SERVICE BULLETIN

40790 Chain Brake Shroud Replacement for use on HPS513CB and HCS8160CB Chain Saws

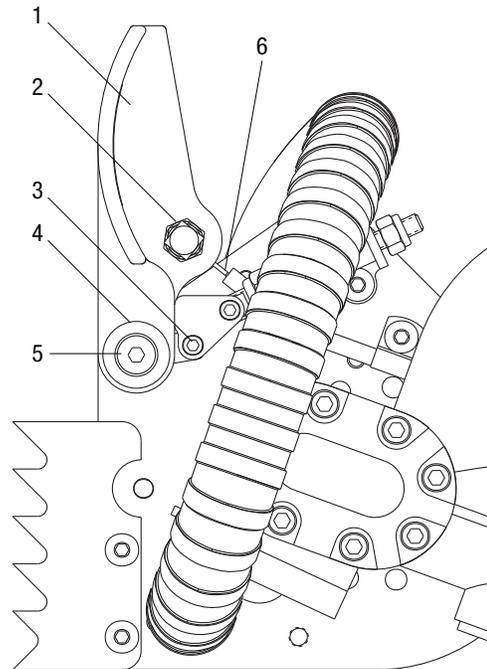
1. Loosen bowden pin (2) to release cable (6).
2. Remove shoulder bolt (5) and washers (4).
3. Remove socket head cap screw (3).
4. Slide cable (6) from bowden pin (2) on shroud (1).
5. Repeat steps in reverse order, replacing shroud (1), shoulder bolt (5), and washers (4) with new configuration (shown below) contained in kit.
